# Index 410 Concrete Barriers

Redesign all concrete sections and reinforcing details for Single-Slope Barriers as part of the MASH Implementation Plan. Reorganize and redevelop all Index Sheets to improve quality, including the redrawing of all details to scale and the rewriting of all notes for added clarity.

#### **COMMENTS AND RESPONSES**

**BLACK** = Industry Review Comments **RED** = Standard Plans Response

BAR 4C1

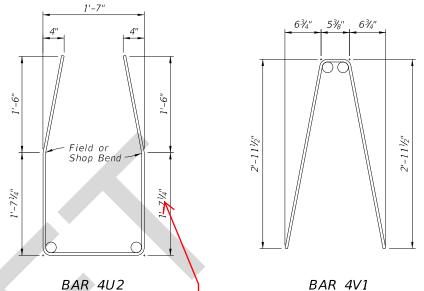
- 5. Is purpose of Bar 4C1 solely to keep the two #4 longitudinal bars at the top of the wall? This hoop bar will not be very rigid (unless 4 points of contact are tied) and would often "rack" during slipforming. I would suggest making it optional and allowing slipform mold to have "tunnels" to feed the 2 #4 bars (as is currently done with the 2 bars in current Standard and VH walls Y<=6"

- 6. If Bar 4C1 has to remain in drawing, at what height (e.g. Y>2") is it required?
- 7. This should be reduced to 2.5" or the bottom cover for the 38" Height and Short Grade-Separated barriers should be increased to 3" for better continuity across the different sections

Bars 4C1 are required for structural integrity purposes. Okay as-is.

Agreed. Will add a note to use Bars 4C1 where required for segments where Y is 2" or greater. Change made.
- 7. This should be reduced to 2.5" or the bottom cover for the 38" Height and Short Grade-Separated barriers should be increased to 3" for better continuity across the different sections

updated for new increased bottom cover on Sheet 5

SHEET 5 of 22

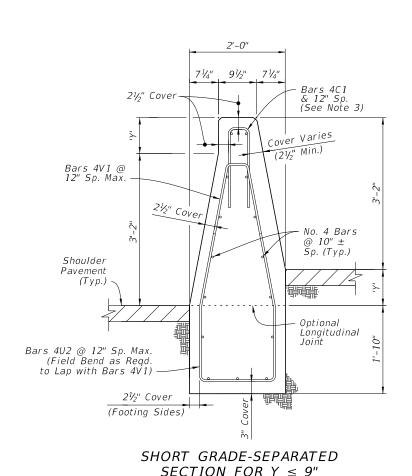
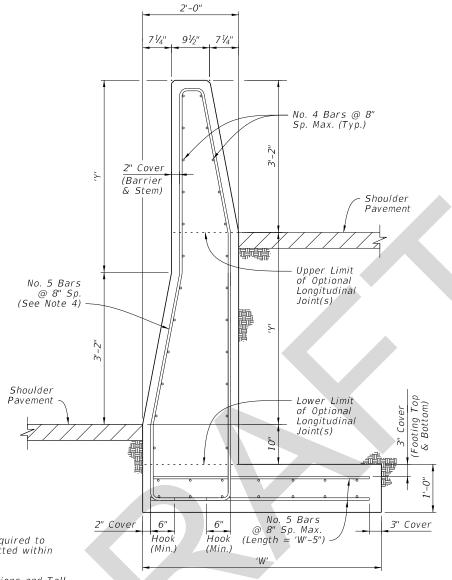
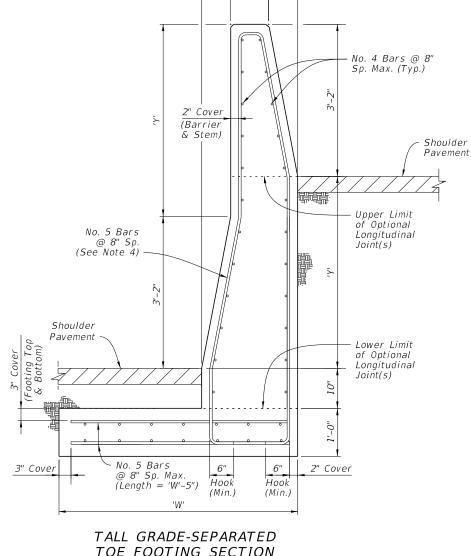
- o Tall-Grade Section Dimension Table: Suggestion to show a height (Y) of >9" to 1'-0" in the first column, since the 'Short Grade Separated Section' is for Y</= to 9".

- o Tall-Grade-Separated Heel Footing Section: When the height (Y) between adjacent pavements is small (for example, Y=1'-0"), it may not be possible to construct the full depth of the roadway stabilization thickness, and the roadway pavement base would be close to or atop of the footing. This may create a potential for longitudinal cracking of the roadway flexible pavement along the tip of the footing, since footing is much stiffer than the roadway embankment. Should consider increasing the 10-in. vertical dimension.

- Tall Grade-Separated Toe Footing Section: It shows the 10-in. vertical dimension from the top of the shoulder pavement to the top of footing. Same comment as above with regard to potential longitudinal cracking.

- o General: Suggestion to include a note (or detail) to provide longitudinal expansion joint when rigid (concrete) pavement is used adjacent to barriers.

- 8. Where is Bar 4Y?
- 9. Are there any requirements for this surface of these joints (e.g. Note 4 of Sheet 2)?
- 10. It will be difficult to order bars with correct lengths for splicing on the low side profile for walls with Y-values less than 18" because the splice would have to extend into the single slope profile. Each bar would have to be field bent (because the Y-value changes)--this costs extra. How important is this splice?

- 11. Spacing needs to be identified (longitudinal bars in footing).
- 12. Does this note conflict with (or supersede) Note 8 on Sheet 2? (Comment points to Note 3, reduced vertical steel spacing requirement)

- Tall-Grade Section Dimension Table: Suggestion to show a height (Y) of >9" to 1'-0" in the first column, since the 'Short Grade Separated Section' is for Y</= to 9".</li>
   To conservatively apply the table, it's implied that Width, W, handles up to the Height Y shown above it. That said, we can make this clearer by labeling Y as "Max." Height. Change made.
- o Tall-Grade-Separated Heel Footing Section: When the height (Y) between adjacent pavements is small (for example, Y=1'-0"), it may not be possible to construct the full depth of the roadway stabilization thickness, and the roadway pavement base would be close to or atop of the footing. This may create a potential for longitudinal cracking of the roadway flexible pavement along the tip of the footing, since footing is much stiffer than the roadway embankment. Should consider increasing the 10-in. vertical dimension.

#### This will remain as-is per past practice. Okay as-is.

- Tall Grade-Separated Toe Footing Section: It shows the 10-in. vertical dimension from the top of the shoulder pavement to the top of footing. Same comment as above with regard to potential longitudinal cracking. See above.
- General: Suggestion to include a note (or detail) to provide longitudinal expansion joint when rigid (concrete) pavement is used adjacent to barriers.

This will remain as-is per past practice. Okay as-is.

Agreed. Change made.

The callout is now updated to Bar 4V1. Change made.

- 9. Are there any requirements for this surface of these joints (e.g. Note 4 of Sheet 2)? No. Okay as-is.
- 10. It will be difficult to order bars with correct lengths for splicing on the low side profile for walls with Y-values less than 18" because the splice would have to extend into the single slope profile. Each bar would have to be field bent (because the Y-value changes)--this costs extra. How important is this splice?

The splice is important on both sides for impact moment capacity. Per our discussion, freedom of steel configuration is permitted per the notes to maintain continuous equivalent steel in locations shown by whatever method is preferred by each contractor to accommodate the varying heights. Okay as-is.

The "No. 4 Bars @ 8" Sp. Max. (Typ.)" callout defines the max. spacing for these footing bars using the "Typical" or "Typ." label. Additionally, the small quantity of bars drawn is visually evident. Okay as-is.

No. As the note provides, this is an additional requirement for the specific case of Transverse Joints in "Tall Grade-Separated Sections" not requiring continuous steel across the joint. That said, free ends would not be expected to occur where adjacent shoulder grades are at largely different elevations, so no free end reinforcing is provided specifically for these sections (they would be transitioned to symmetrical Median Barrier on Sheet 2 before ending, if not connecting to a Traffic Railing). Okay as-is.

11 of 22

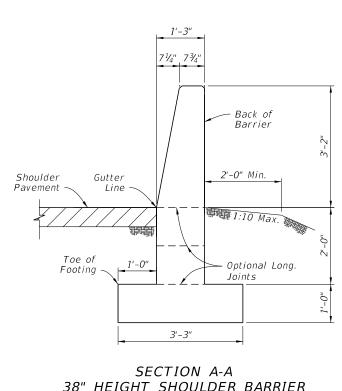
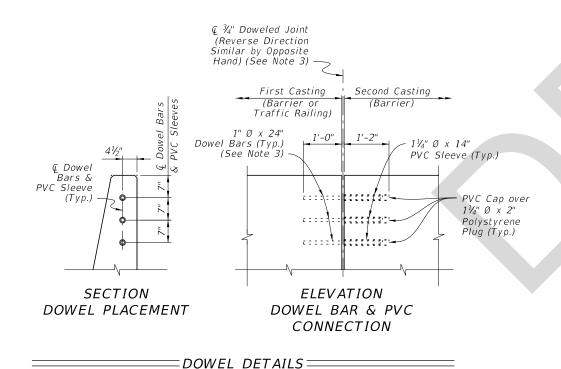
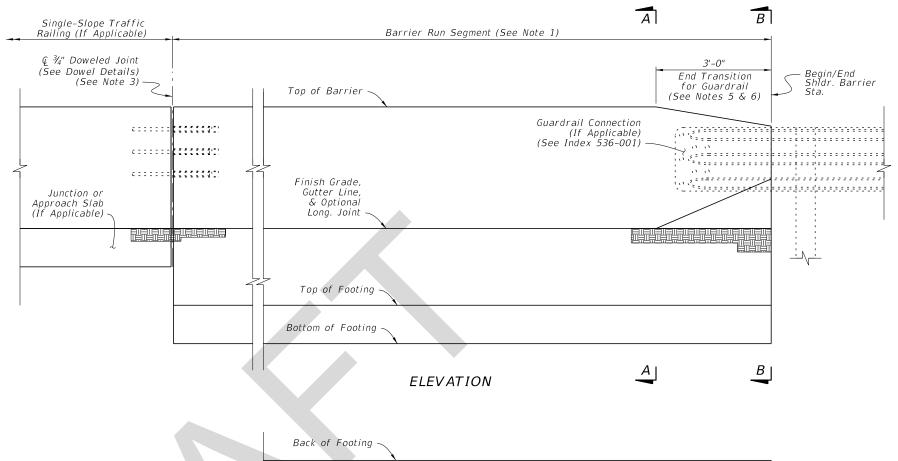
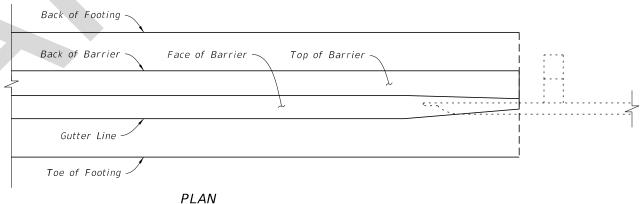
- 5. Sheet 11 of 21 Contains details for transitioning the new single slope median barrier back to existing F-Shape Median Roadway Barrier. Is this detail also intended to be used for transitioning to existing F-Shape Median Bridge Barrier?
- 6. If not, is this detail provided elsewhere in the Standard Plans?
- 7. If elsewhere, consider including a note directing the contractor to the appropriate index for such transitions.
- 8. Sheet 11 of 21 —Is this detail also intended to be used for transitioning to existing F-Shape Bridge Shoulder Barrier?
- 9. If not, is this detail provided elsewhere in the standard plans?
- 10. If elsewhere, consider including a note directing the contractor to the appropriate index for such transitions.

5. Sheet 11 of 21 — Contains details for transitioning the new single slope median barrier back to existing F-Shape Median Roadway Barrier. Is this detail also intended to be used for transitioning to existing F-Shape Median Bridge Barrier?

Yes, see Sheets 11 and 18. Okay as-is.

Yes, the end shapes are compatible between all combinations of Traffic Railing and Concrete Barrier of both F-Shape and Single-Slope. The detail and note generically references F-Shape "Section" to accommodate both Traffic Railing and Barrier (which have the same face shape, historically compatible) Okay as-is.
